GROUP	MODEL
Voluntary Emissions Service Campaign	2025MY Carnival (KA4)
NUMBER	DATE
SC333	June 2025

VOLUNTARY EMISSIONS SERVICE CAMPAIGN

SUBJECT: ENGINE CONTROL MODULE LOGIC IMPROVEMENT (SC333)

UPGRADE EVENT:

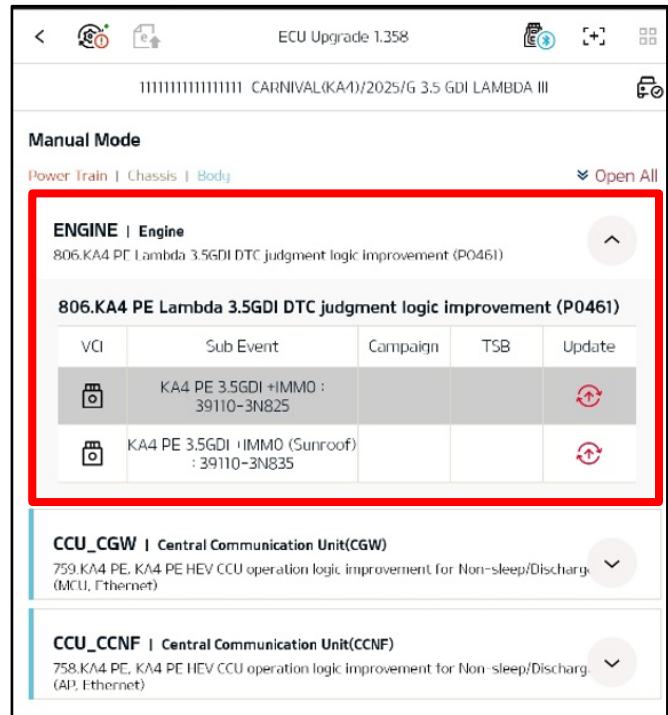
Select the applicable **'Engine'** system module and the Event Group.

- **806.KA4 PE Lambda 3.5GDI DTC Judgment Logic Improvement (P0461)**

Verify the affected vehicle Calibration Identification of the applicable ECU ROM ID and reference the Information Table on page 3 as necessary.
